State Significant Development Application 15\_7421

Response to Submissions Report

SSD - Mortdale Resource Recovery Facility

FIGURE 1 – VEHICLE QUEUING PLAN

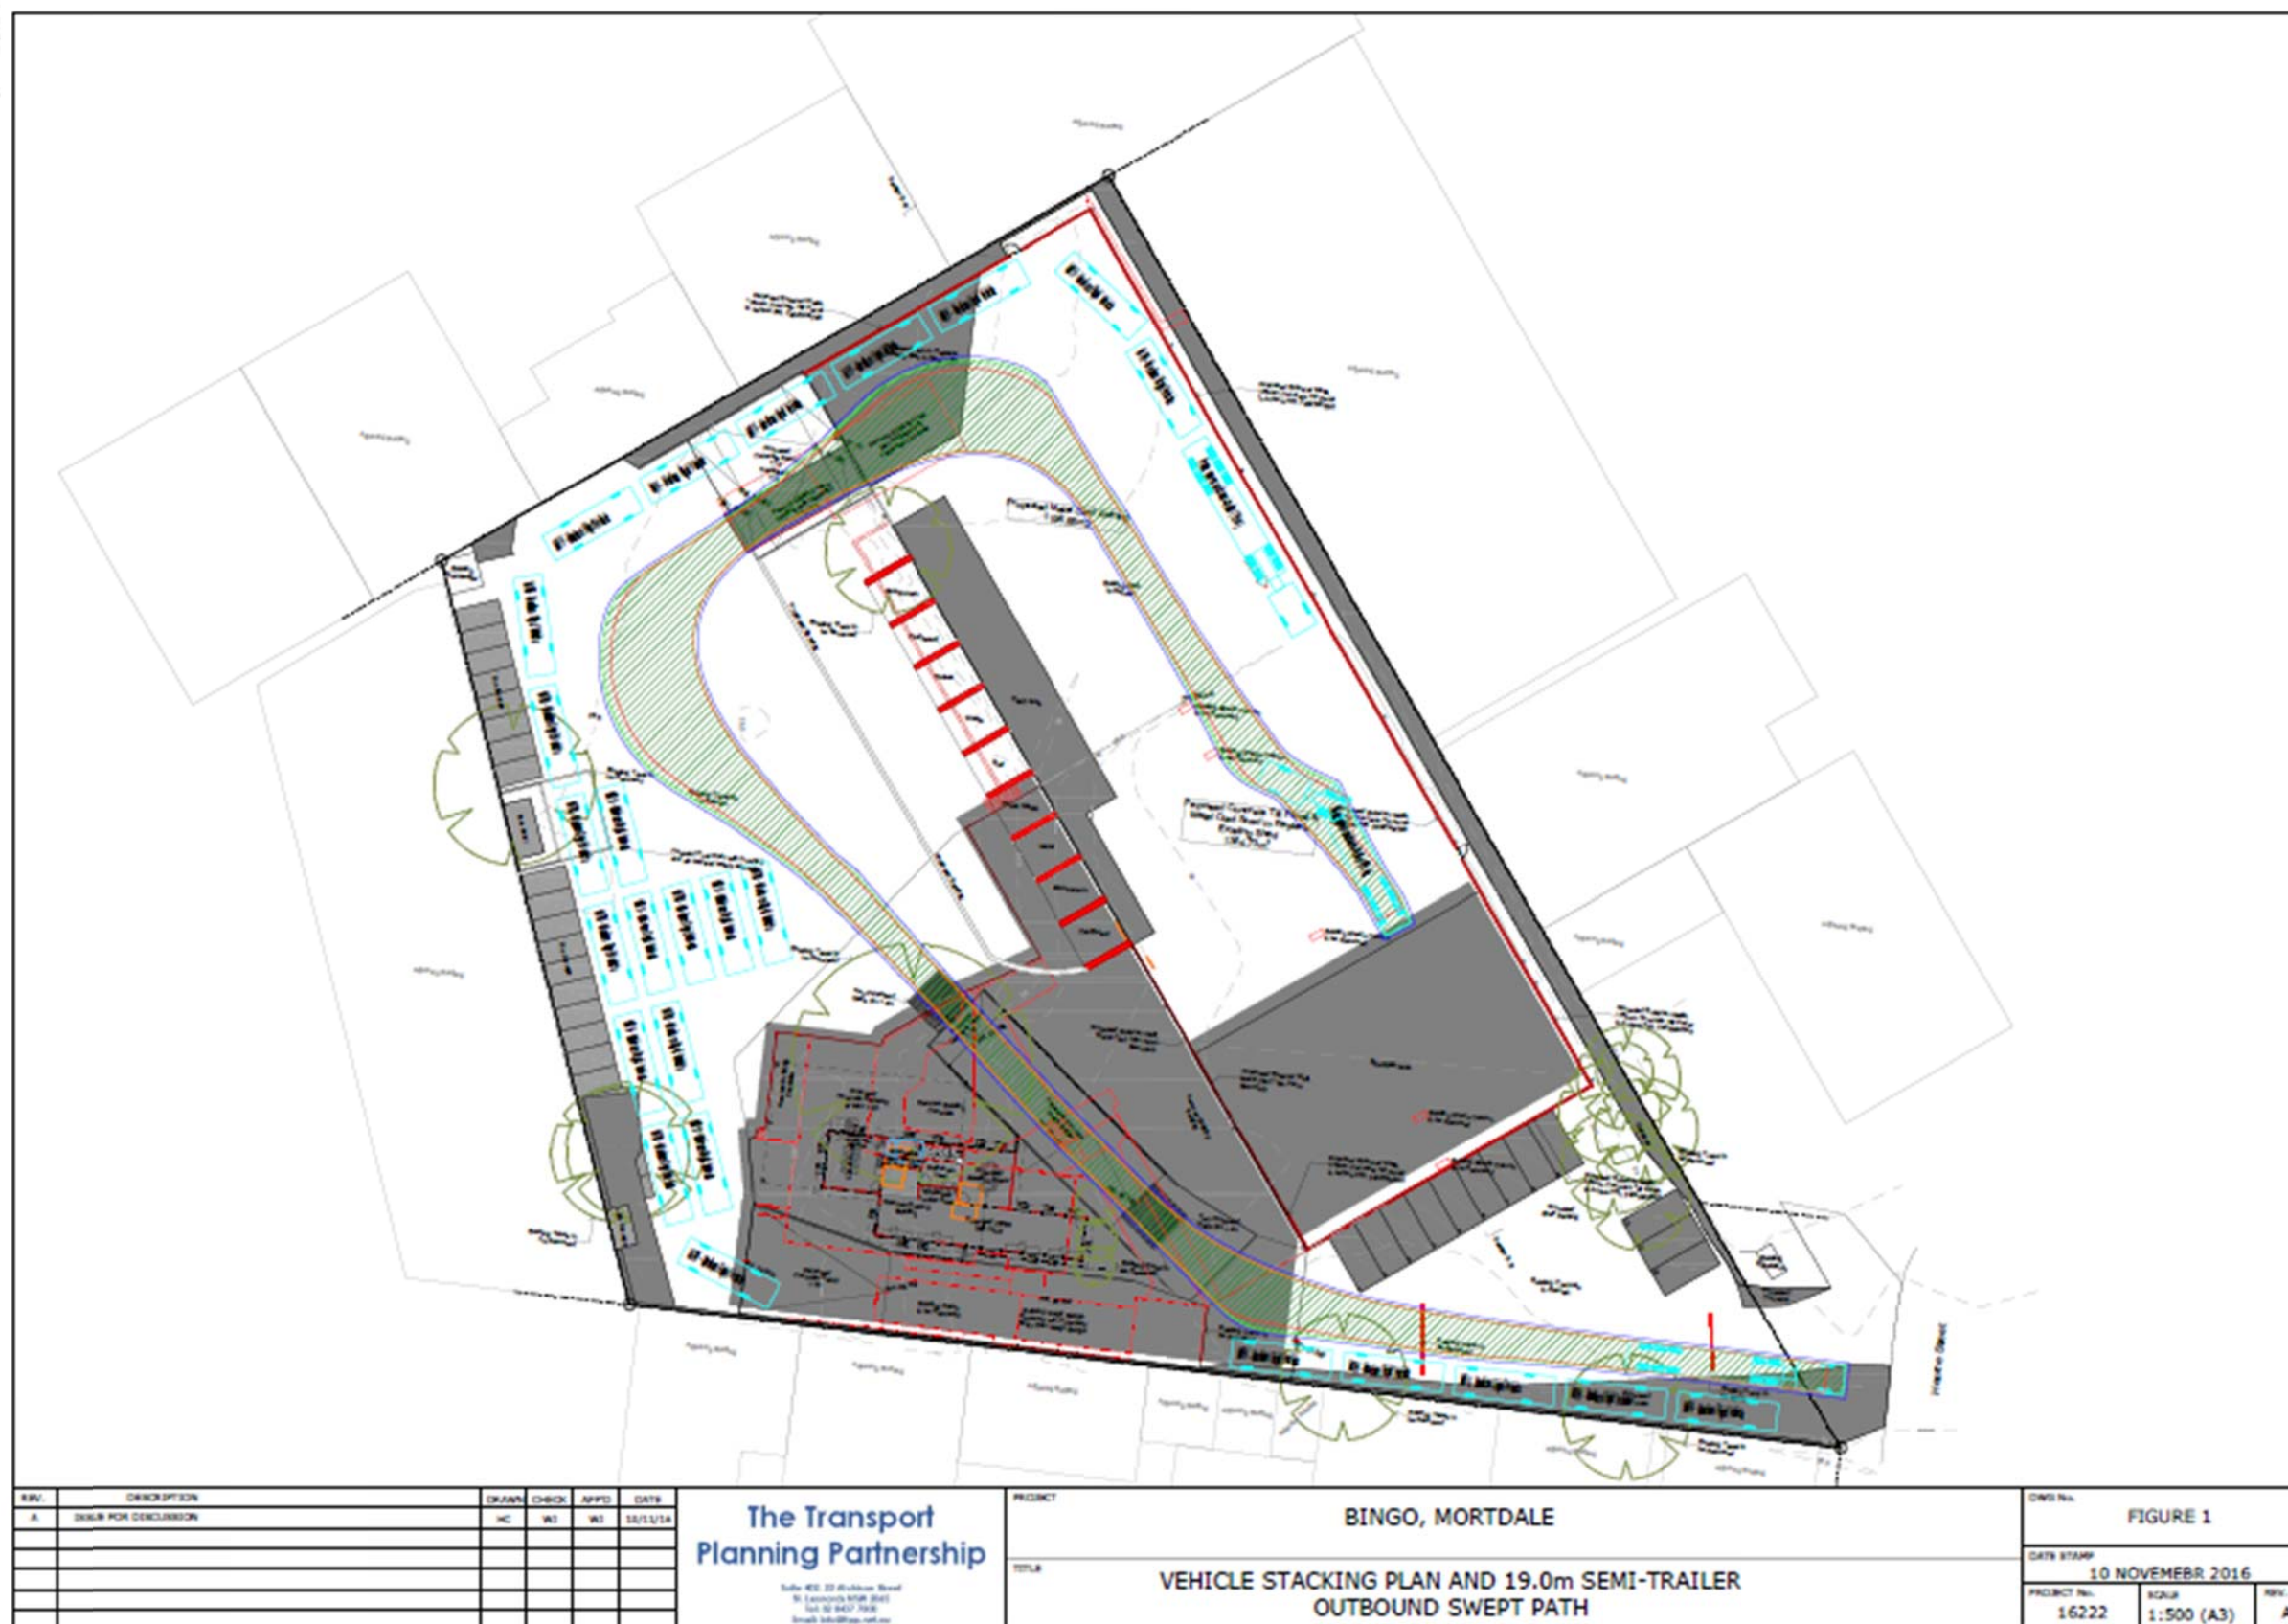
A vehicle queuing plan has also been prepared and submitted with the EIS which would allow for up to 64 vehicles to be managed on site in any one hour during peak periods and this is reflected in Figure 1 below, which demonstrates the ability to hold up to 28 vehicles at any one time, if necessary

**Figure 3: 24-hour traffic distribution**

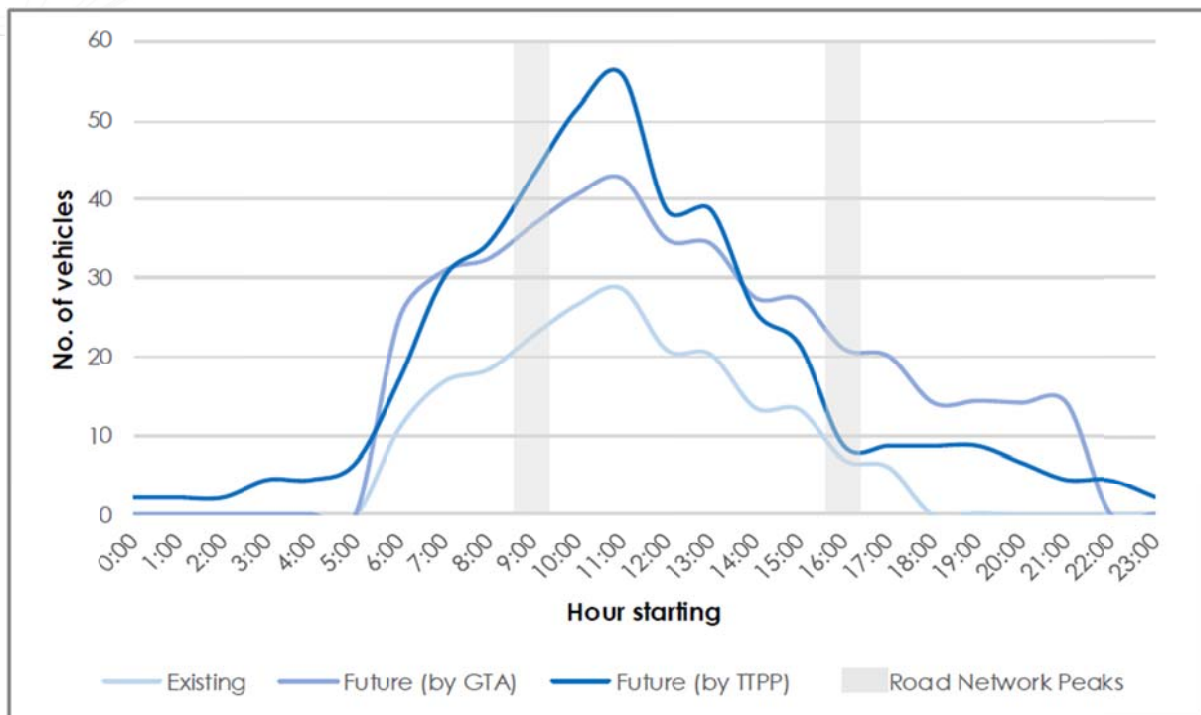
The TTPP Response to Submissions letter (18/11/2016) predicted the distribution of traffic volumes over a 24-hour period (**Figure 3**) based on a similar hourly distribution as currently

As can be seen in Figure 3, the main effects of redistributing the predicted traffic include:

Incorporating TTPP's revised traffic distribution, changes in the estimated truck volumes would be expected to be absorbed by the road network. The key difference is apparent between 11:00am-12:00pm during which 13 less trucks have been accounted for in the GTA report. In summary, TTPP's assessment of the site's capacity concludes that these 13 trucks can be accommodated onsite.

**Figure 5: Site supervision**

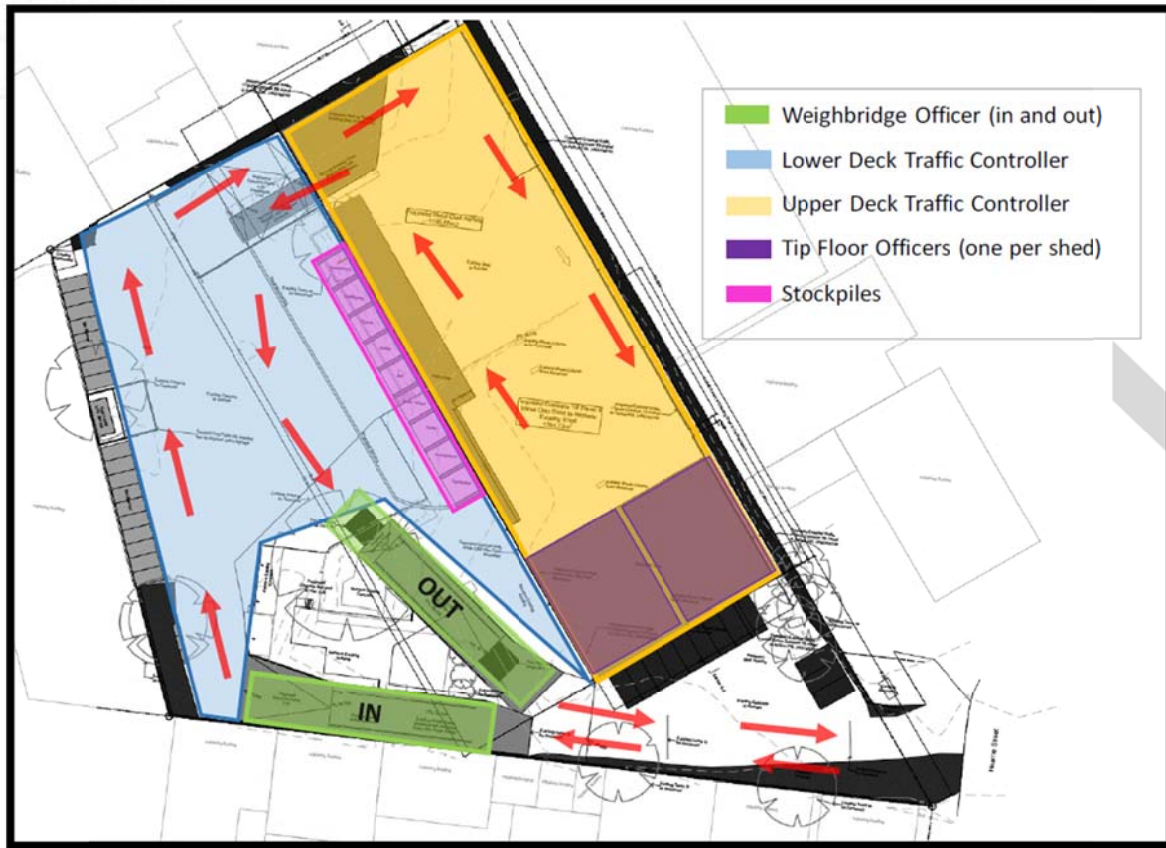
As identified on **Figure 5** below, site personnel will be located at various stations within the site to direct truck drivers and during waste unloading/ loading through the day and night and implement the vehicle stacking plan. Upon entry to the site, truck drivers will be instructed by the weighbridge officer to complete a weigh-in.

As vehicles circulate through the site, drivers will progress to the upper deck where a second traffic controller will manage vehicle flows in the tipping shed. A tip floor officer will be positioned in the tipping shed to assist drivers unload waste. Unloaded trucks will then proceed to the outbound weighbridge where the weighbridge officer will collect final details and authorise the truck to exit the site.

Figure 6 Maximum Predicted Incremental 24 Hour Average PM<sub>10</sub> Concentrations

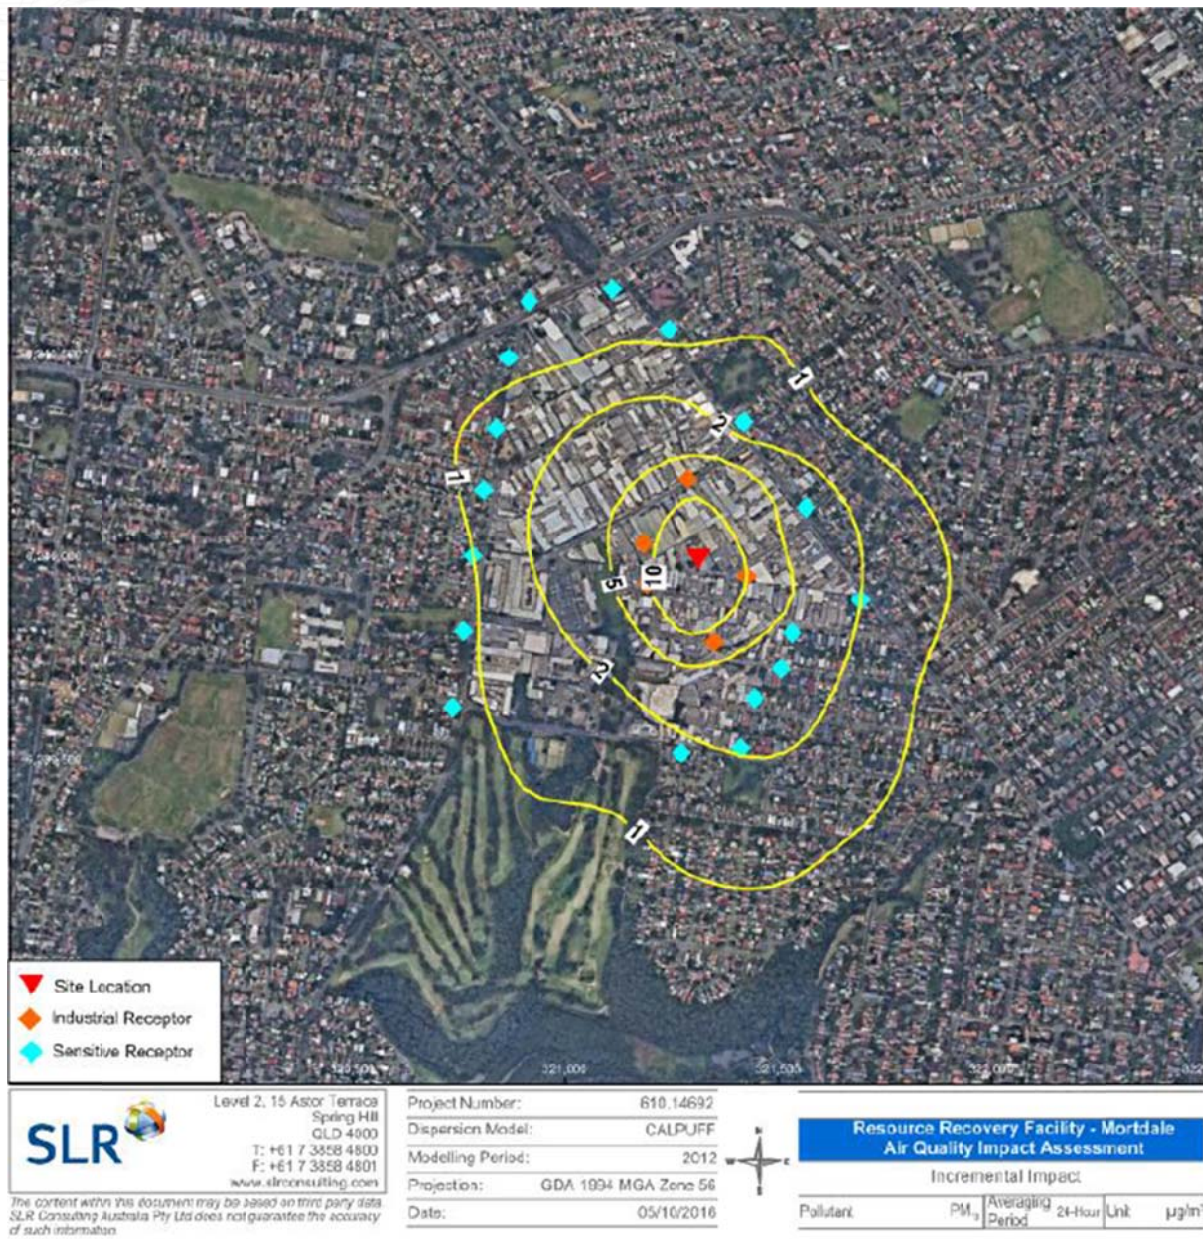
The resulting maximum predicted 24-hour average PM<sub>10</sub> concentrations at surrounding sensitive and industrial receptors are presented at **Table 2** with the additional controls accounted for in the emission inventory, the maximum predicted 24-hour average PM<sub>10</sub> concentrations at all receptors included in the model (including the industrial sites) comply with the assessment criterion of 50 µg/m<sup>3</sup>. The maximum predicted incremental 24-hour average PM<sub>10</sub> concentrations are shown as a contour plot in **Figure 6**.

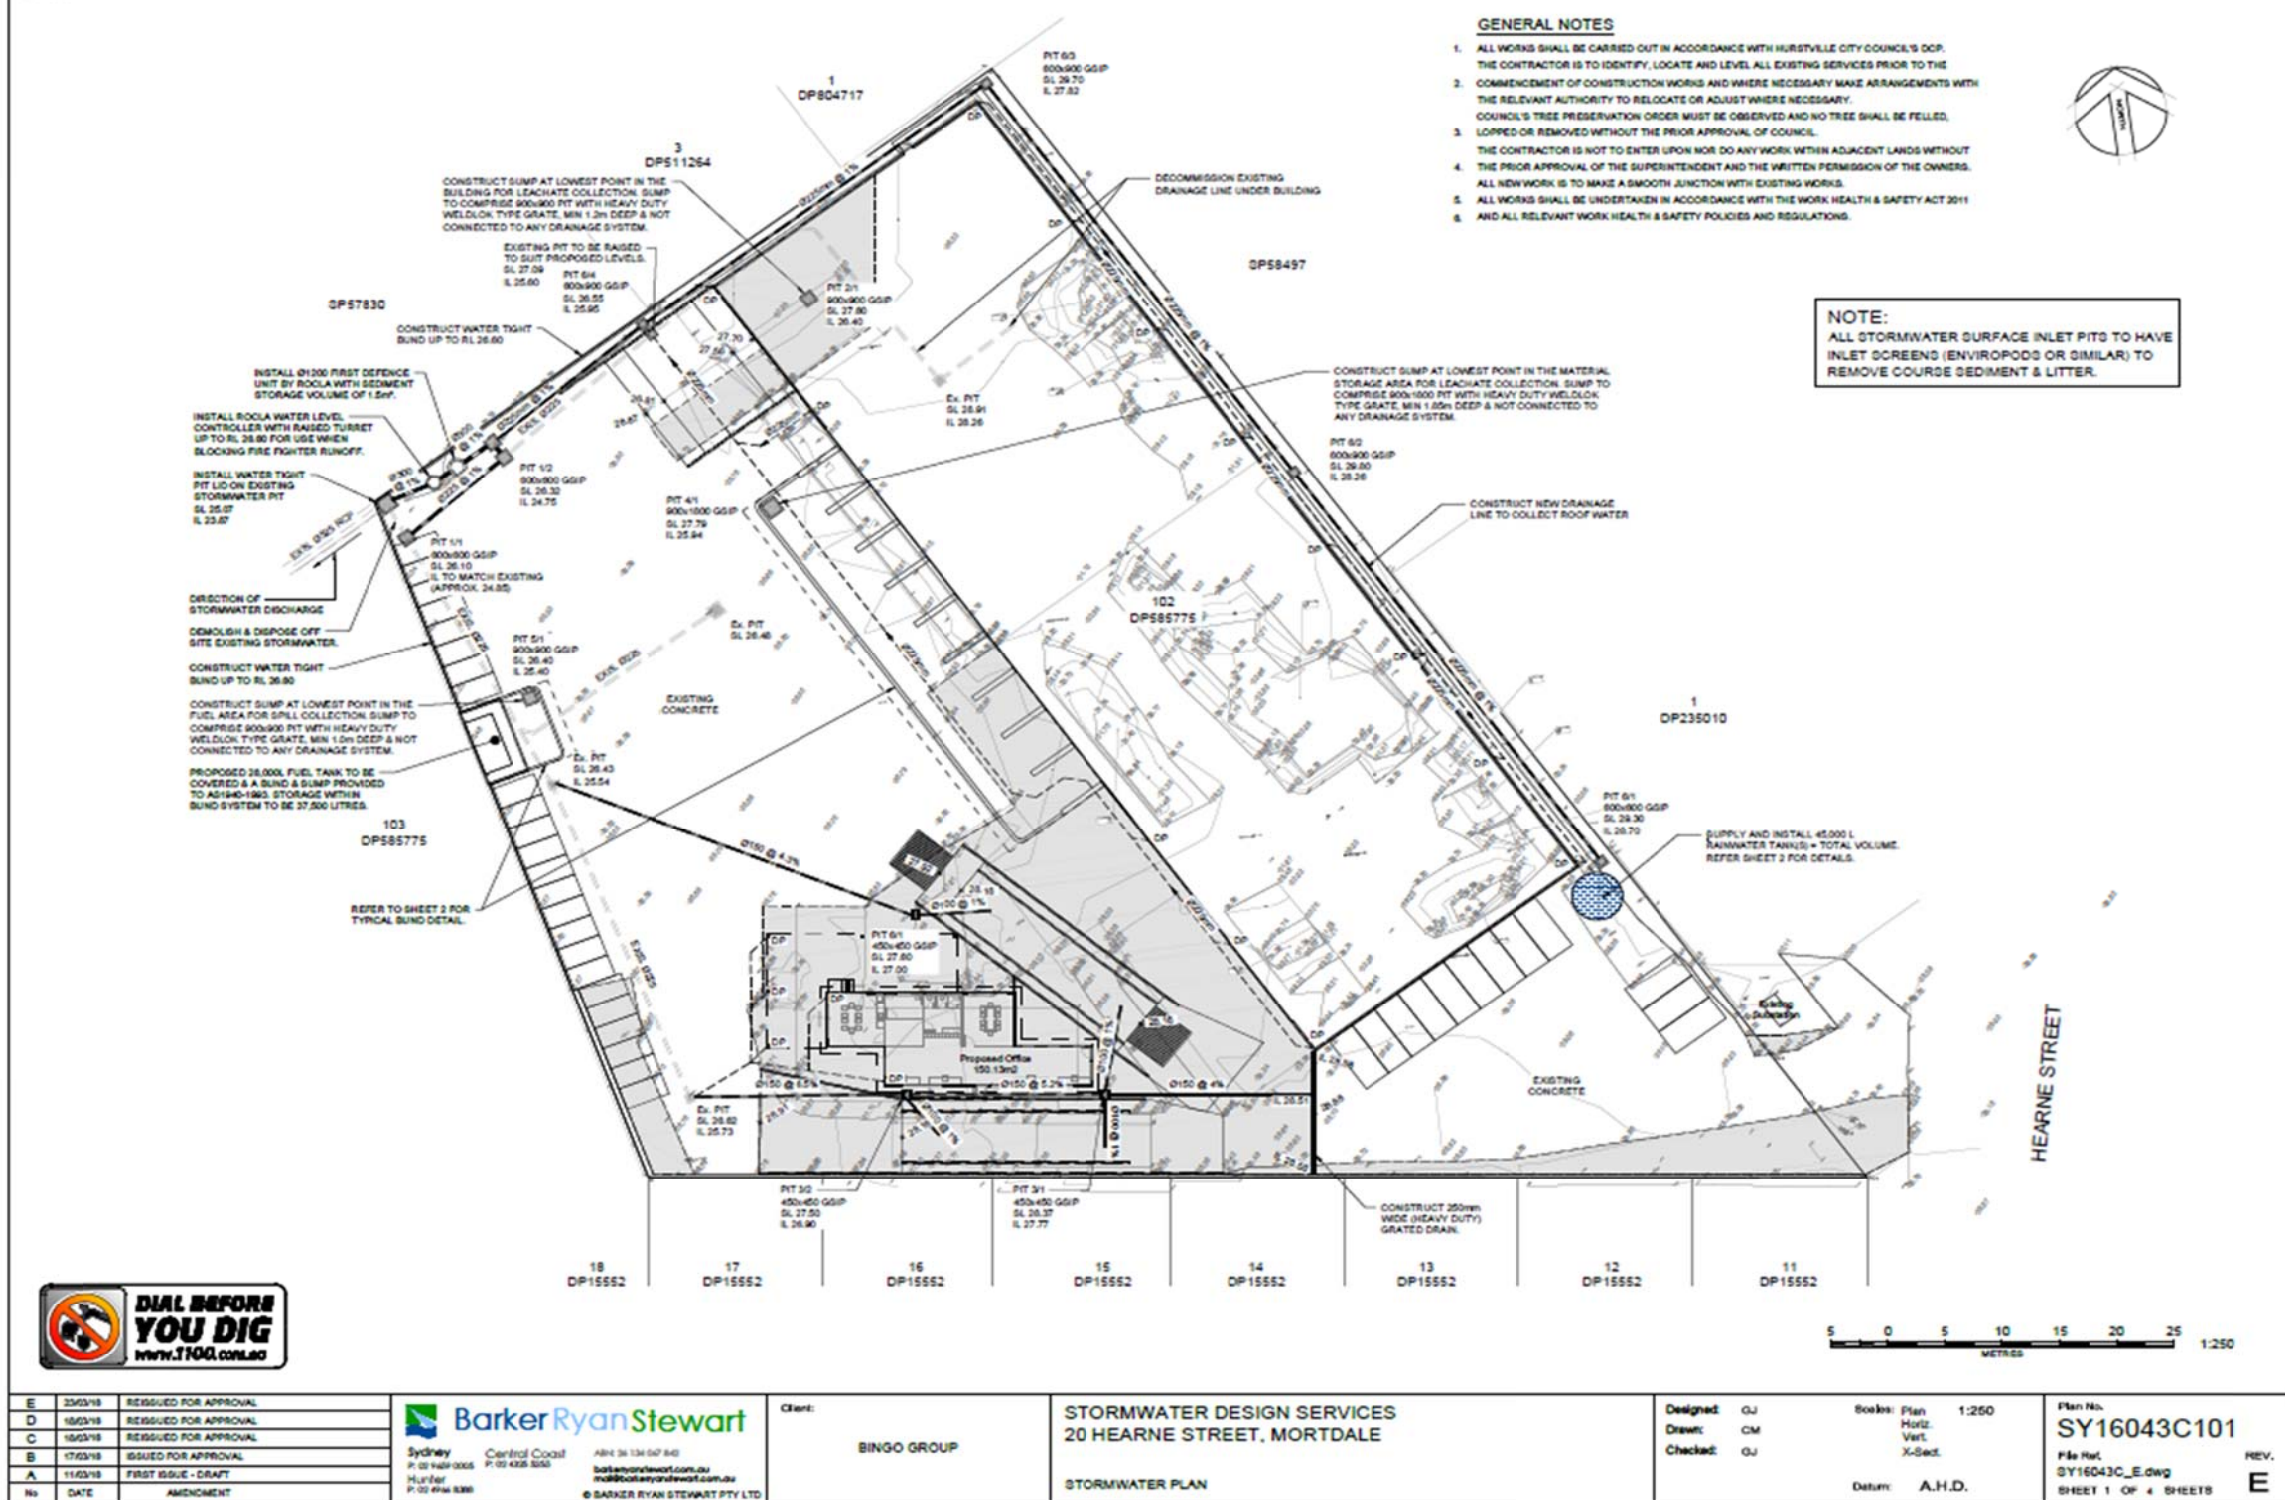
The FSS identified the approximate locality of fire fighting equipment for the Mortdale Facility as reflected at **Figure 7**.
